DS 2022-01 Starboard Drive Definitive Subdivision

Starboard Drive Definitive Subdivision

ADMINISTRATIVE SUMMARY

Stormwater Peer Review (2) – March 21, 2023:

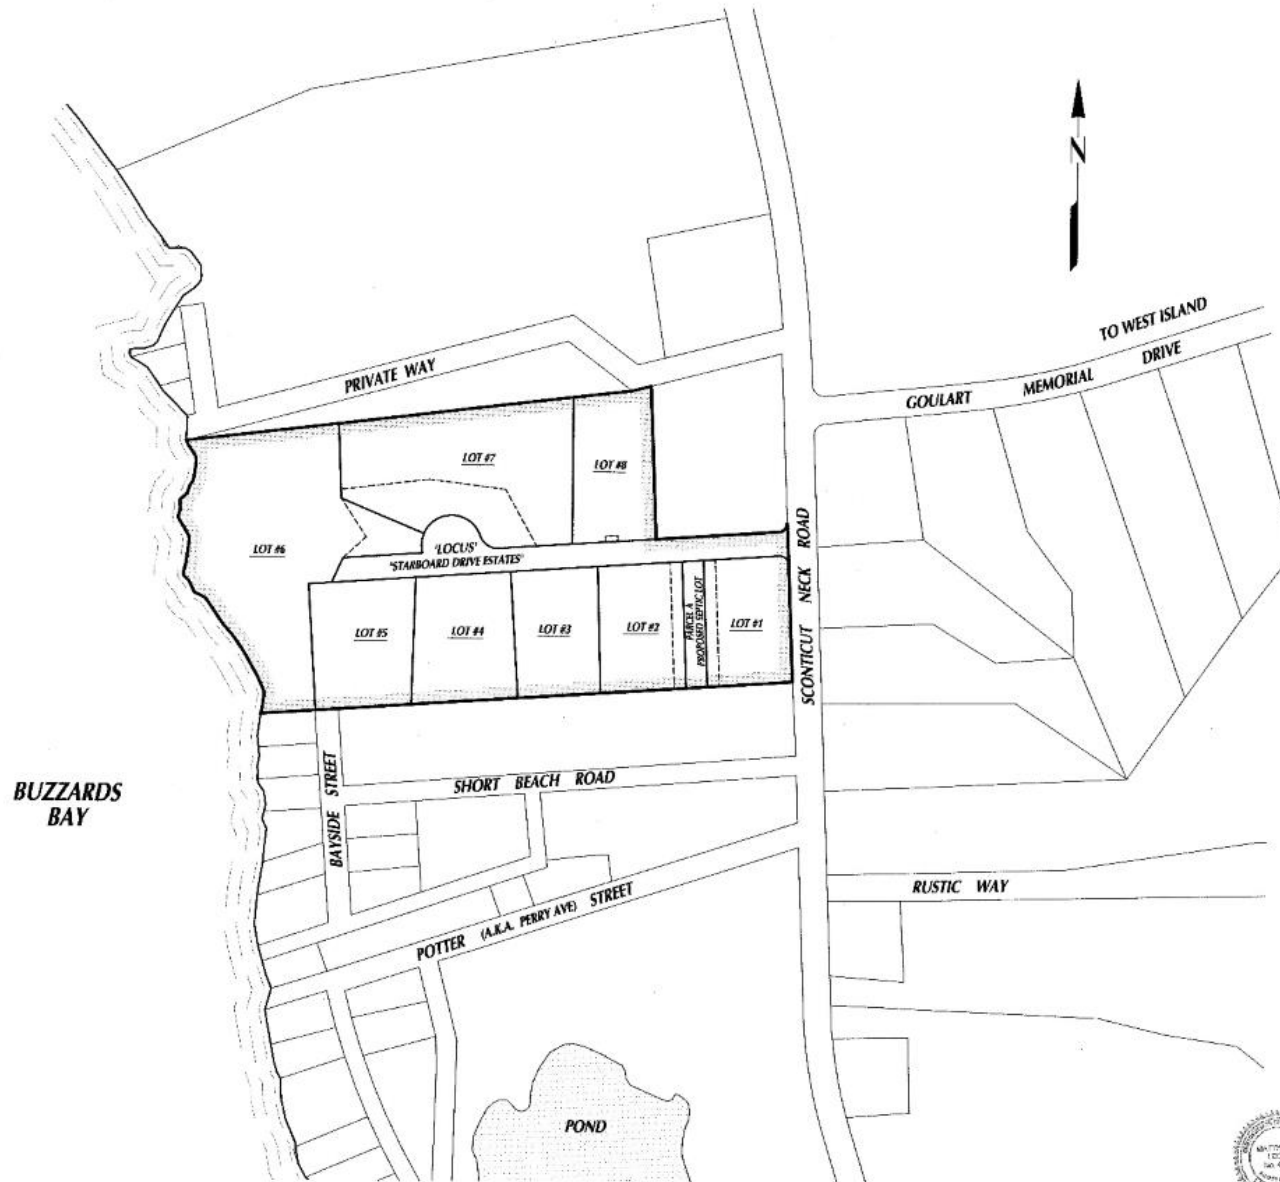
Grading & Utility Plan (Sheet 4):

- Lots #1 & #2 roof drain chambers system do not meet the 50-foot setback. Resolved.
- Roof drain infiltration system do not meet the 2-foot separation to ESHW. Based on the soil test logs, the ESHW for [Lots 1, 2, 3, 4, 7, and 8's roof drain infiltration chambers systems are acceptable. However, Lot number five roof drain infiltration system \(Class V Well\) is within the fifty feet wetland setback requirements. The proposed system is approximately 33' from wetland flag #4-R, and this series of salt marsh wetland flags are located above the 4' contour. This area is designated as HSG 'D' soil and not suitable for infiltration. GCG recommends relocating or removing the infiltration system on Lot 5.](#)

- 198-31.1. C.(2)(g)[6][d] - ...basins/ponds designed ...no steeper than a 4H:1V grade. Ponds A & B have 3H:1V side slopes. Waiver requested. The proposed 3H:1V side slope meets the Massachusetts Stormwater Handbook requirements. Granting the waiver [should not have any adverse impacts](#) to the basin system.

SHEET 5 OF 6 SHEETS
ROADWAY PLAN AND PROFILE

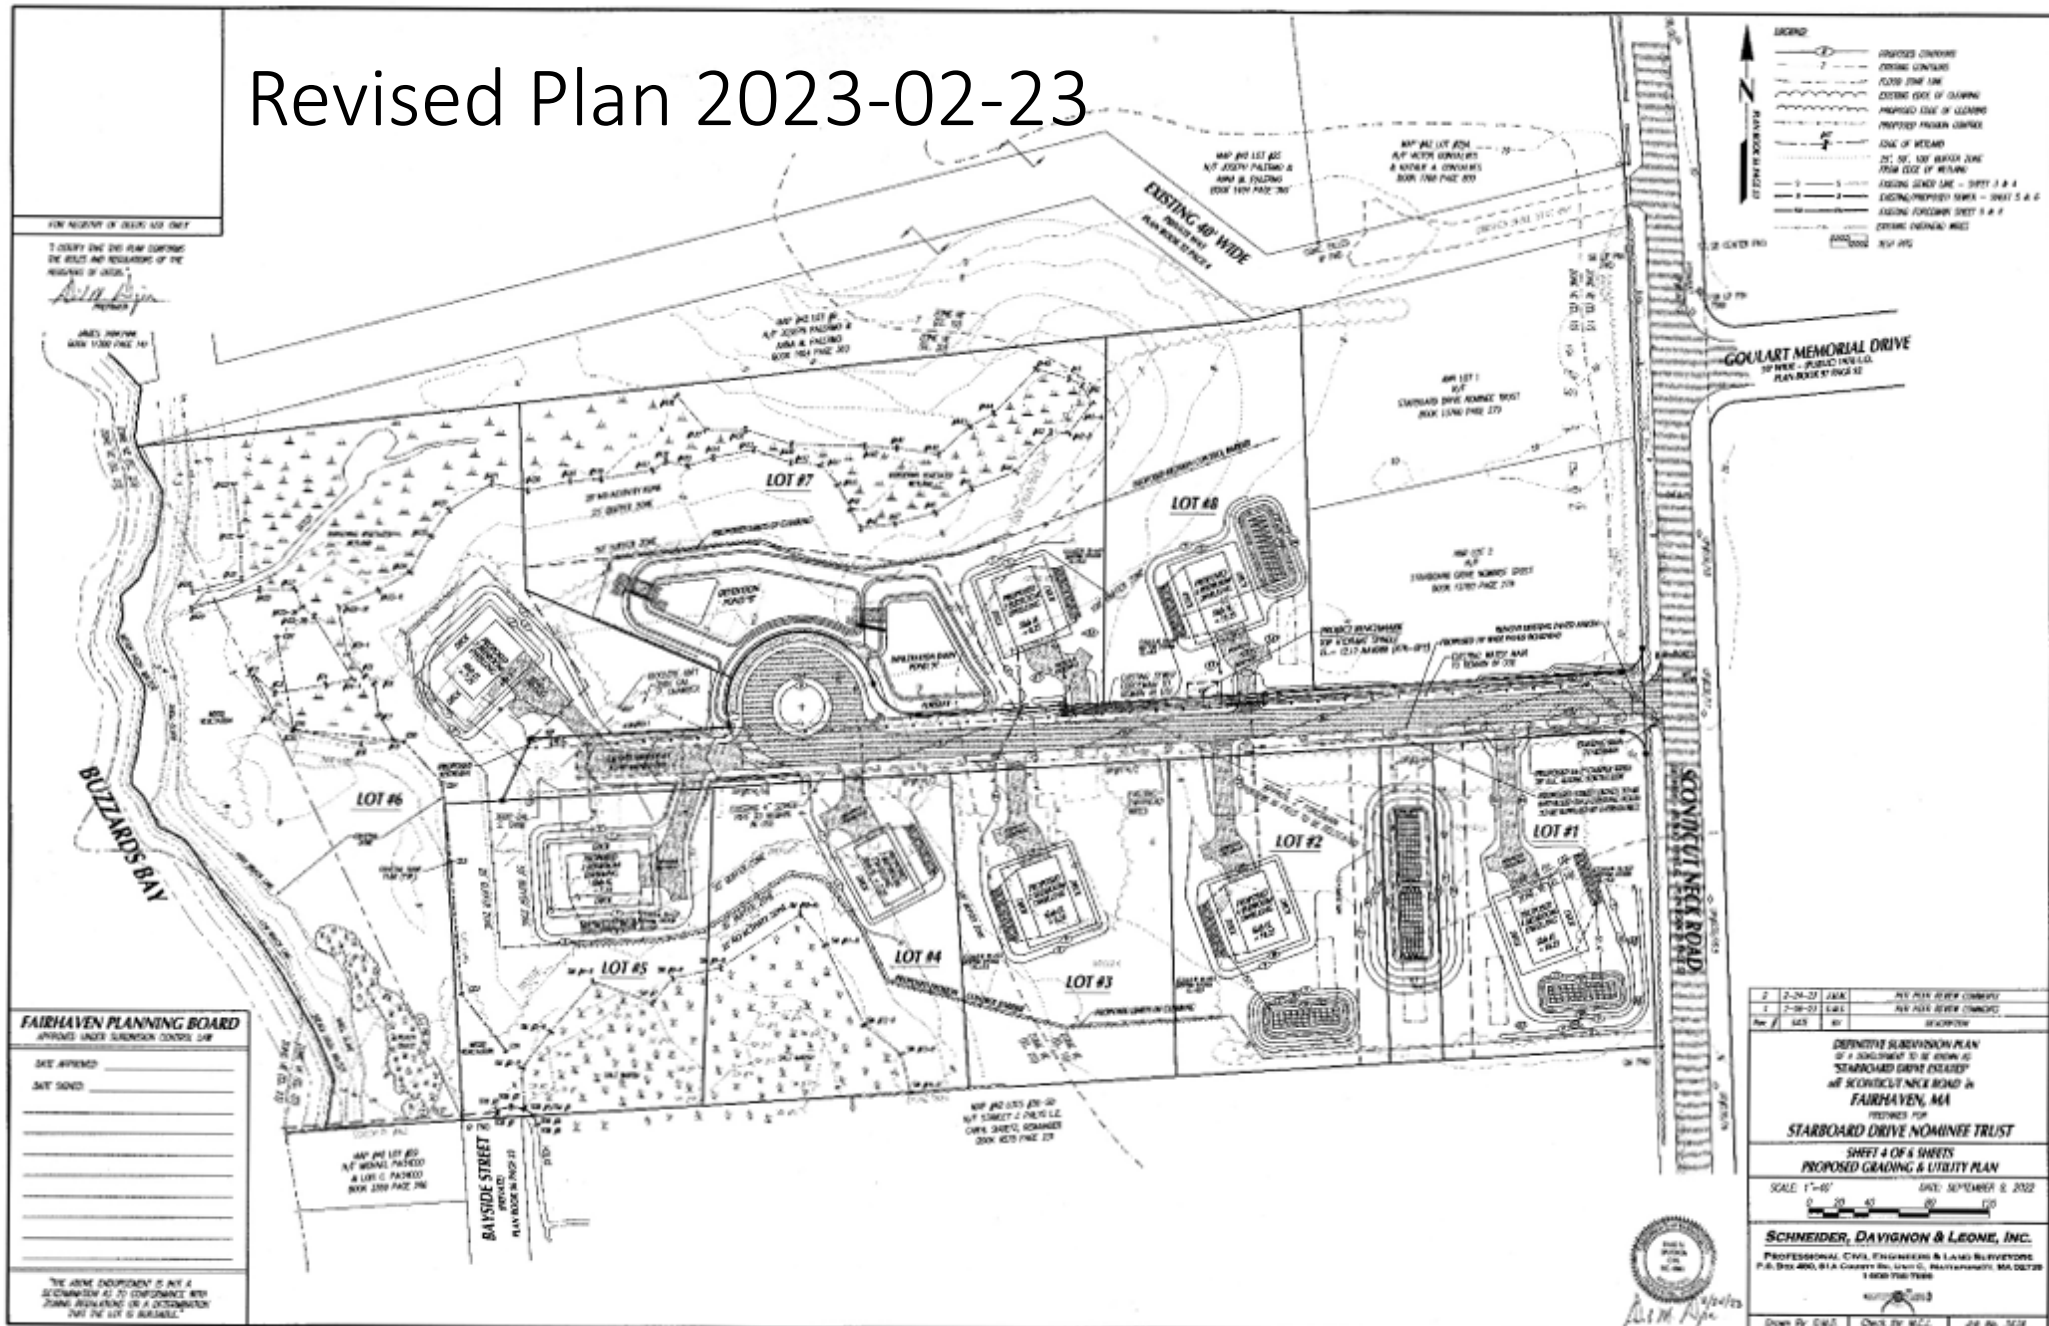
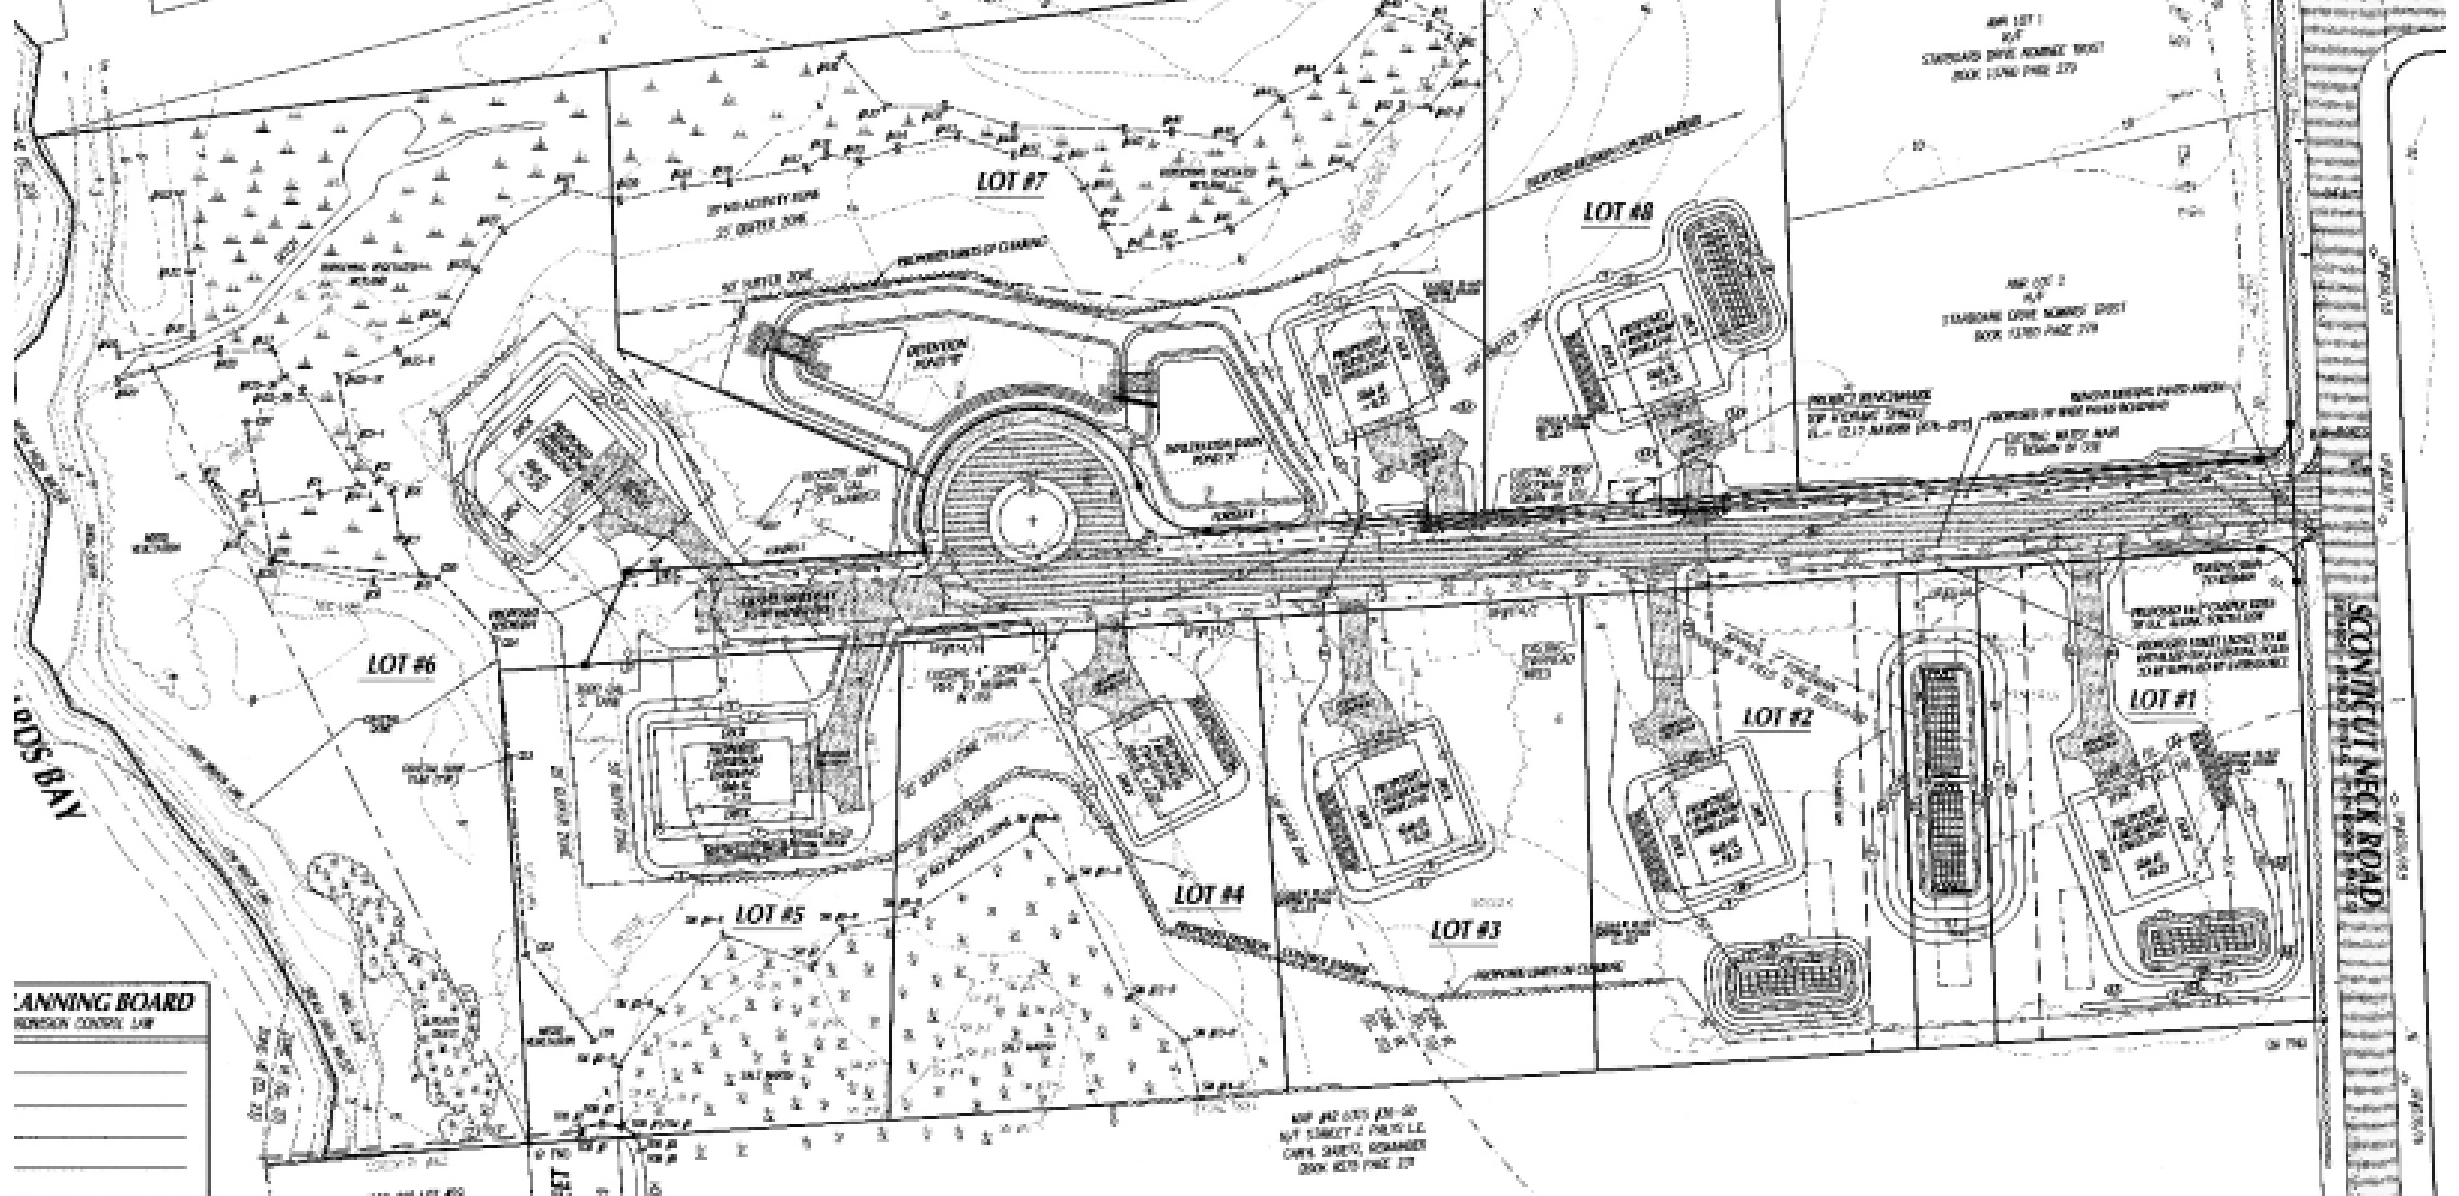
Roadway Plan & Profile (Sheet 5)

- Proposed Water Quality Swales (#1 & #2) do not have a pretreatment device and do not have the soil media thickness required and are close to the ESHW. **Resolved.**

- 198-31.1. C.(2)(k)[1][d] - Design standards, Pond A forebay is only 0.5 feet deep. ...exceeds MSH’s minimum forebay sizing (0.1”) but does not meet FH regulation (2)(k)[1][d] which requires a 4’ deep forebay, local requirements. Waiver requested.

- Design Standards (2)(k)[1][b], ...Portion of the proposed roadway pavement drains directly to the Pond-A forebay, forebay should be sized to receive the 25% TSS removal for pretreatment credit. **Revised forebay meets the 0.25 inches requirements but not the 4’ deep local requirements. Waiver requested.**

- Approximately 75 % of Pond-A and 100% of Pond-B are in the Hydrologic Soil Group ‘D’ area and not suitable for exfiltration. **Based on the soil test logs, Basin A has the 2 feet separation ... Basin B will not meet the minimum 2’ separation requirements and has been redesigned as a dry detention basin. The bottom of Basin ‘B’ is most likely within a foot of the ESHW and could become a wetland basin which will not affect the function of the detention basin, but the maintenance may have to be modified if it becomes a wet basin.**

- Detention Ponds A & B ... do not have the 1-foot of freeboard required (MSH Vol.2, Ch.2, Pg. 90). The emergency spillway should be sized based on Brimful conditions. Basin ‘A’ was designed as an infiltration basin. This basin has 0.5’ freeboard and 1 foot is required by the MSH. A waiver has been requested. The emergency spillway was sized to accommodate the brimful conditions without overtopping the earth berm.

- Ponds A & B’s earthen berm will be constructed with fill material approximately 1.5’ to 2’ above existing grade in the coastal velocity zone. The top of the berm is only 4-foot wide. GCG recommends the width of earth berm be increased to minimum 10-foot width with an impervious core to secure the earthen berms. The entire site is in the coastal velocity zone ‘VE’ (EL. 17 to 20) with wave elevation 13 feet higher than the proposed top of earth berm. The eastern side of basin ‘A’ and the southern side of basin ‘B’ along the cul-de-sac have a berm width of 4 feet. GCG recommends providing earth berm design to protect against the coastal wave action.

- 7. The proposed Basin ‘A’ outlet should be equipped with three (3) – 6-inch diameter pipes as used in the HydroCAD calculations. (Also shown on sheet 6)

- **CC PR 3/28: Please note that the Planning Board has no authority to grant a waiver to MSH requirements for applications to the Conservation Commission.**

SHEET 4 OF 6 SHEETS
ROADWAY PLAN AND PROFILE

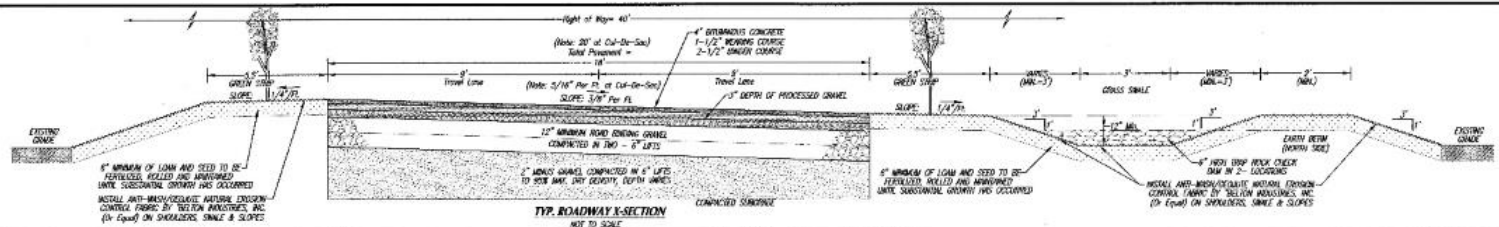
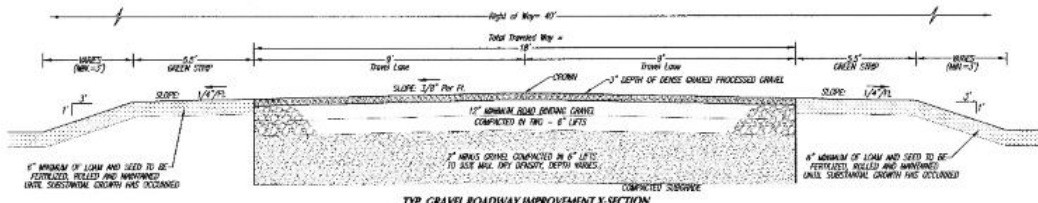
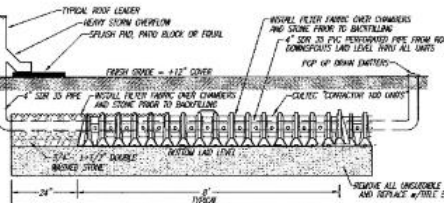
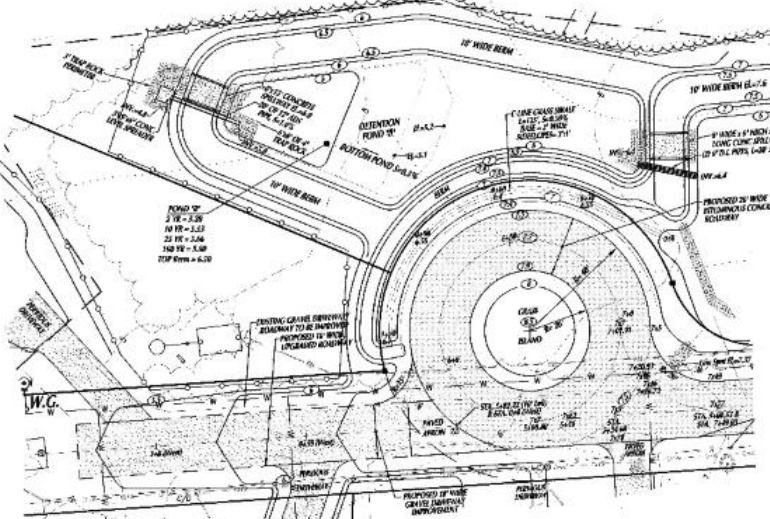
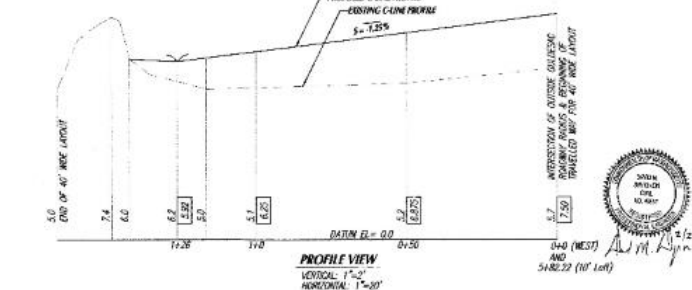
Roadway Plan & Profile (Sheet 6)

- Cul-de-sac forebay removed, resolved.
- Soil test logs indicate 2 feet separation between bottom of basin to ESHG. Resolved.
- Outlet Control Structure detail should be provided. Resolved.

- Roof drain leader overflow control detail should be provided... Resolved.
- Proposed roadway pavement is classified as new-development and requires a 90% TSS removal and 60% of Total Phosphorus, based on average annual load. The applicant is considering this development as redevelopment and requesting the Planning Board treat it as such. GCG’s interpretation of the new-development condition was based on the MSH which considers all new pavement as new development. However, if a development proposes gravel roadway in a new project, the Town would be most likely to treat it as an impervious surface. Therefore, GCG does not object to the argument that this is a redevelopment project. Nevertheless, the status should be decided by the Board.

- **CC PR 3/28: This is a new development condition for the purposes of the MSH.**
- Lot #5’s infiltration system is within the 50’ wetland setback and should be relocated.

- 198-31.1. C. (2). (n).[6] – Requires storm drains at least 12” diameter...Waiver has been requested. This waiver should not have any adverse impacts to the drainage design.

- Typ. X-Section of Roof Recharge Trench – Finish grade should be 12” minimum to meet the manufacturers minimum cover requirements for unpaved conditions.

BBC/TNC/NHESP BioMap2 Coastal Adaptation Analysis

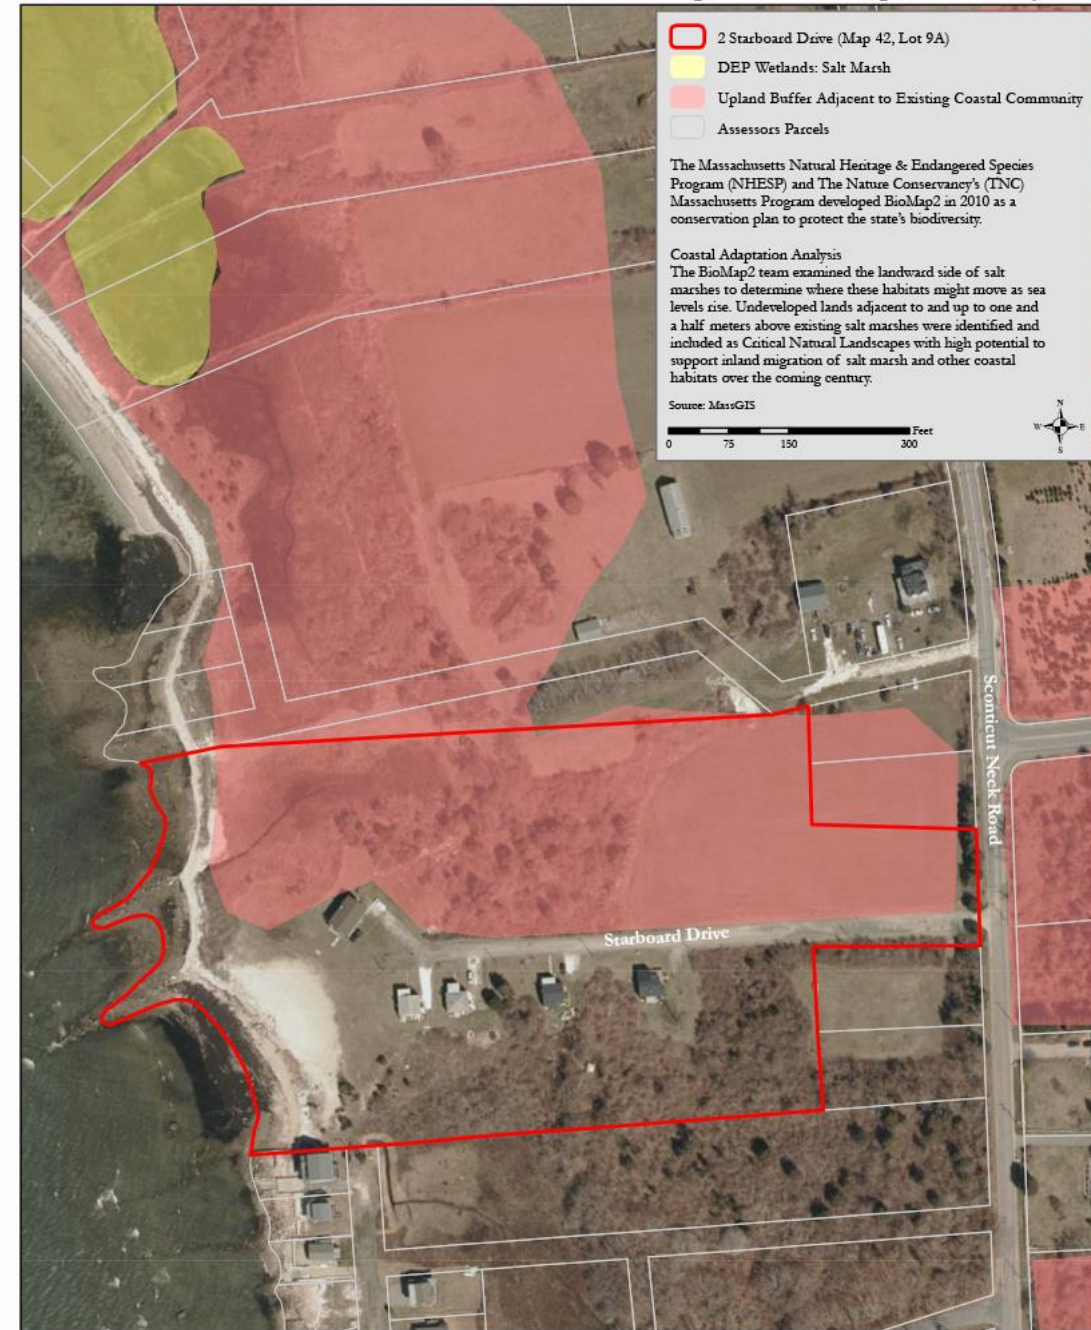
- The conservation agent attached a map created by the Buzzards Bay National Estuary Program showing areas that are likely to be critical for salt marsh migration to adapt to sea level rise. The yellow is DEP mapped salt marsh and the red are the areas that may be crucial to supporting coastal resiliency and salt marsh migration.
